Access Compliance Report Public Rights-of-Way (Pedestrian Signals)

Main Street: GRASSY_KNOLL_LN Cross Street: MEANDERING_TRAIL Location: NW

ADA ID: SGRK211019131924 Signal Type: One Push Button-Non APS Overall Compliance: No Severity Scores: BTN 1: 25 BTN 2: N/A No BTN: N/A

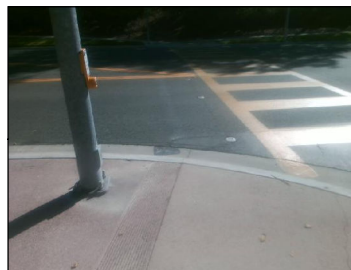
OC Std/PROW: MUTCD 4e.08, R404.2

Possible Solutions: Replace Signal Push Button With APS Button. Remove & Relocate Sign.
